#	Comment/Question	Party	Draft Response
Fuels Forecast			
General Comments/Questions			
1	Slide 52 shows percentages of likelihood (PIRA) for the Base, High, and Low case natural gas scenarios of 45%, 25%, and 30%, respectively. The further slides do not refer to these percentages and PHP assumes that there is no specific weighting given to the probability of occurrence of the three separate cases in the proposed analysis. PHP would appreciate confirmation, or an explanation of why and how these percentage figures are to be utilized in the analysis.	PHP	Correct. The percentage likelihood figures by PIRA are quoted by NS Power for information purposes only.
2	Slide 55 shows that for the natural gas Base Case (Expected), there is no premium for the periods 2018-2030 or 2030-2040. This appears to assume as a Base Case that the U.S. Northeast and Atlantic Canadian gas market structural issues are fully mitigated by 2018 for the entire Planning Horizon. What level of confidence does NSPI place on this assumption to the extent that it can utilize it as the Base Case, considering the occurrence of the current unexpected natural gas pricing conditions, the capital works required to address

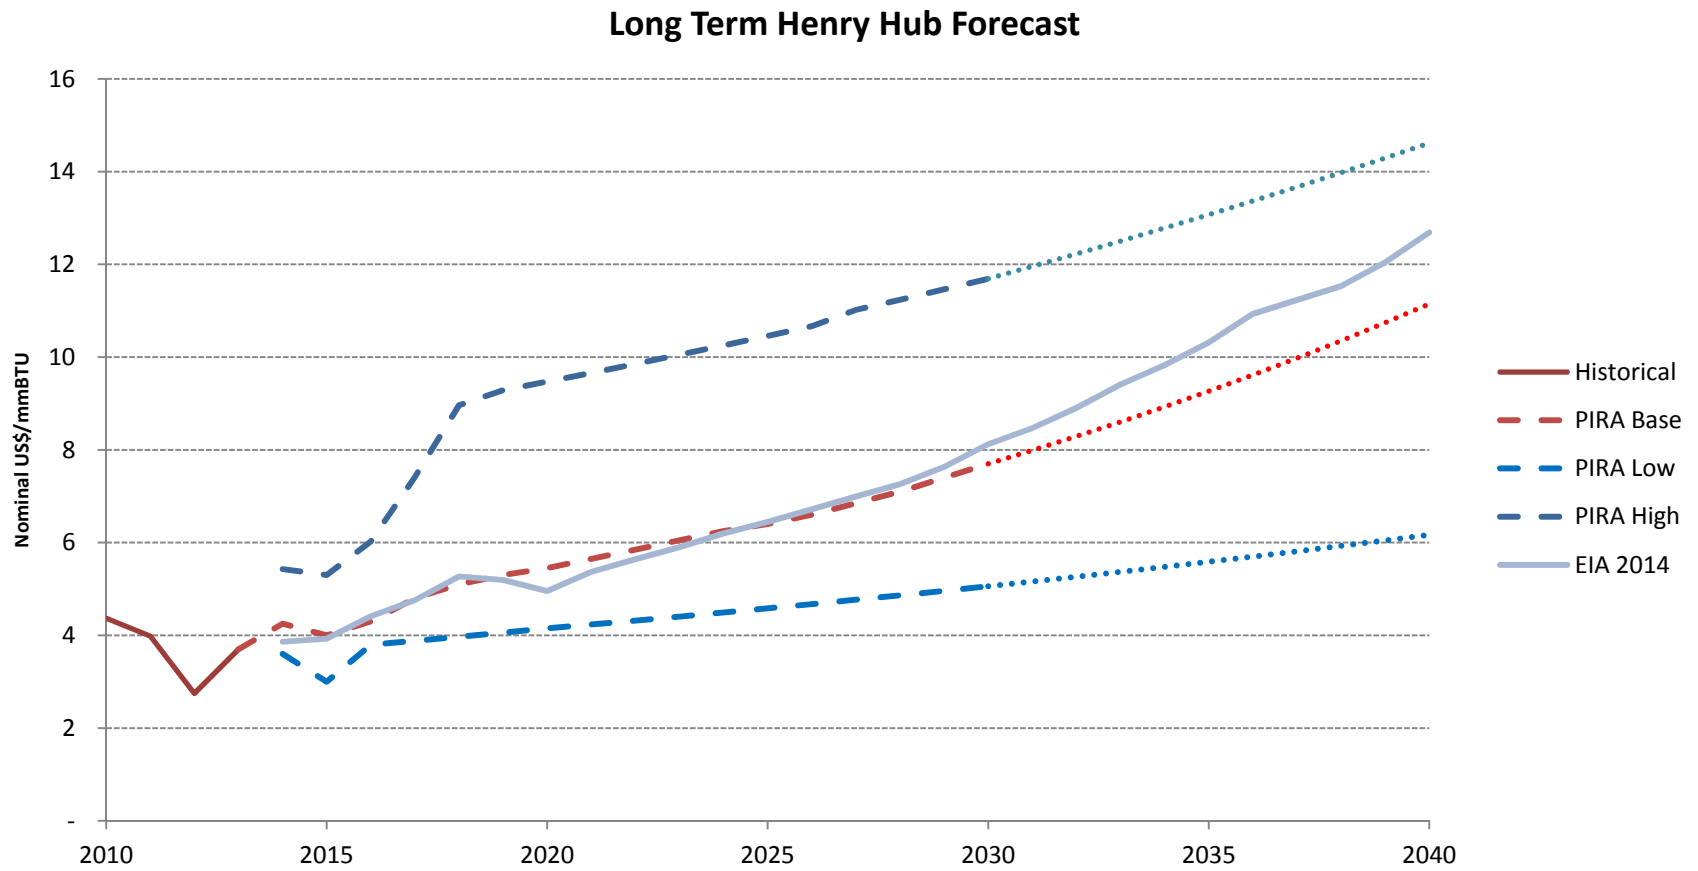
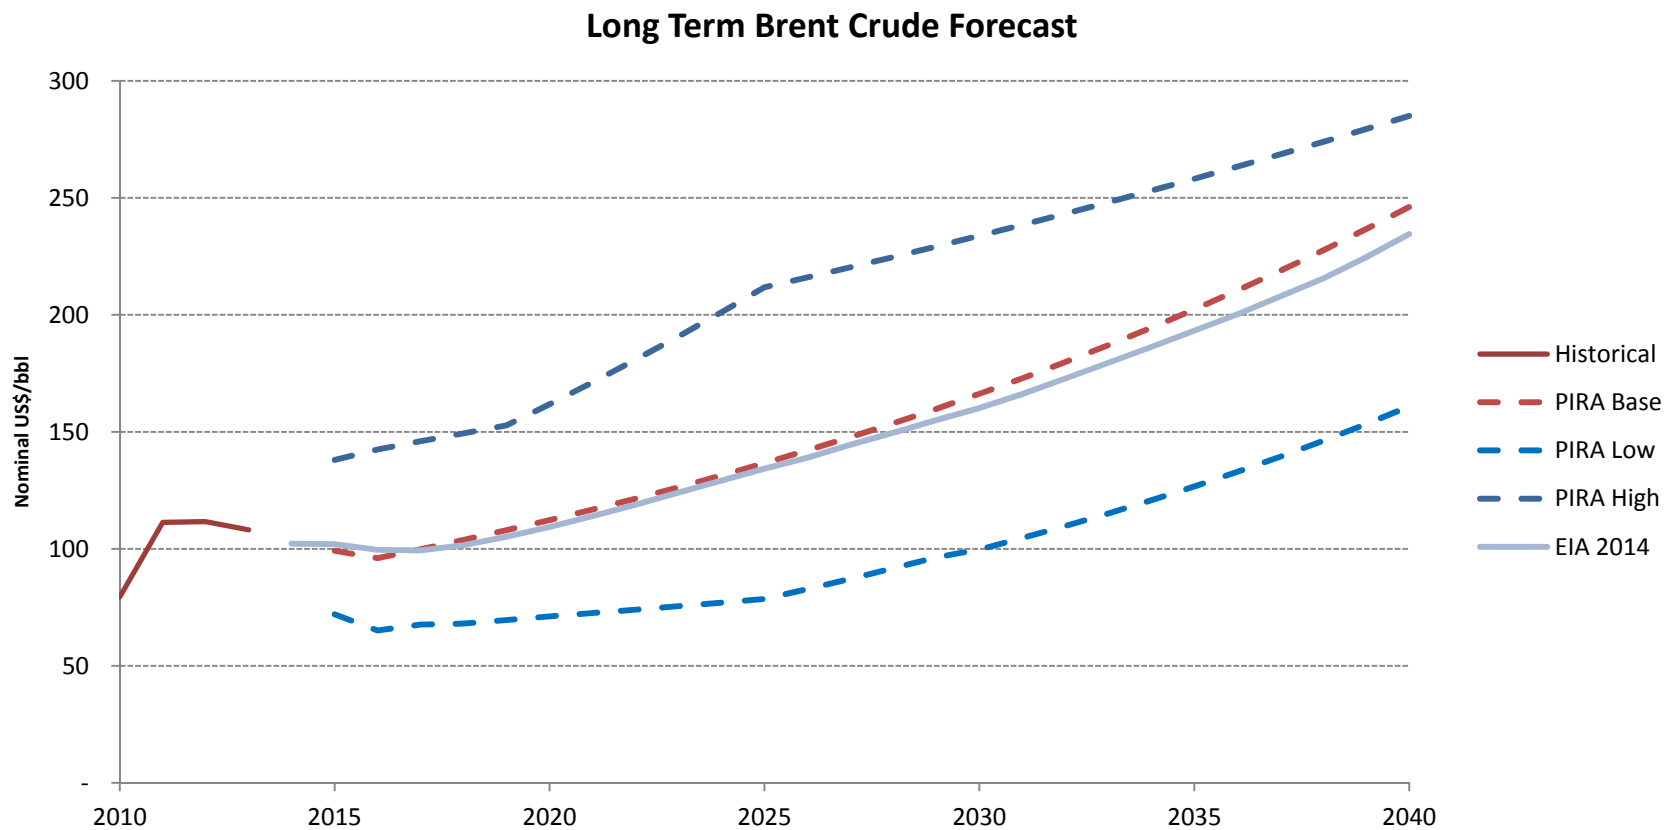
5	In order to better understand the impact of different fuel forecast assumptions, it would be helpful if NSPI would provide a graph comparing historic and forecast fuel costs over the planning horizon (in \$/mmbtu) on a single graph. Where there are relative price differentials that diverge from historic differentials, it would be appropriate for NSPI to comment on the market (or other) assumptions that influence the change.	Industrial	Please refer to Figure D.
6	NSPI should consider using other fuel forecasts.	Industrial	NS Power considered the use of the EIA price forecasts but elected to rely on existing commercial relationships (such as PIRA and EVA) considering ready access to professional insight, support and visibility to underlying assumptions. NS Power's preferred third party providers' forecasts are in-line with EIA's expectations according to Annual Energy Outlook 2014 Early Release, Reference Case. Please refer to Figures B and C.
